Colt Doster

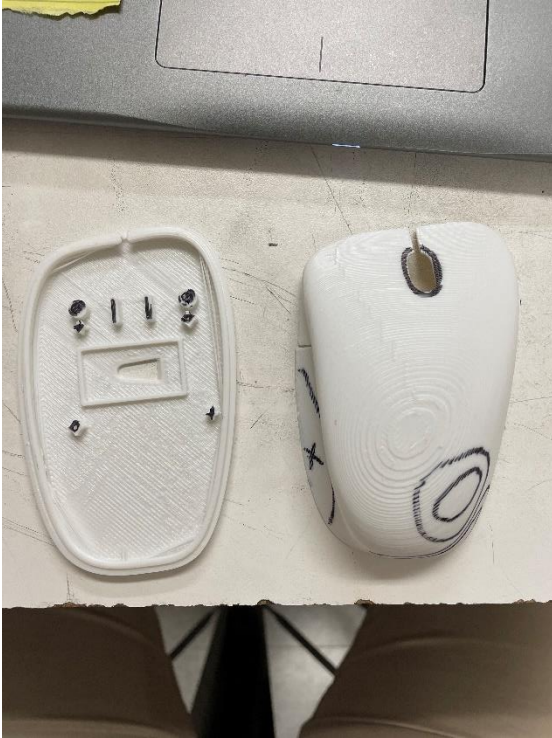
- Hole for roller wheel is not big enough, will need to expand it
- The thumb divot is at too steep of an angle, it is blocking the snap pins from accepting the mouse top
- In an ideal world, the back part of my mouse would be higher so it could meet my palm (represented by the “topographical lines” drawn on the mouse)
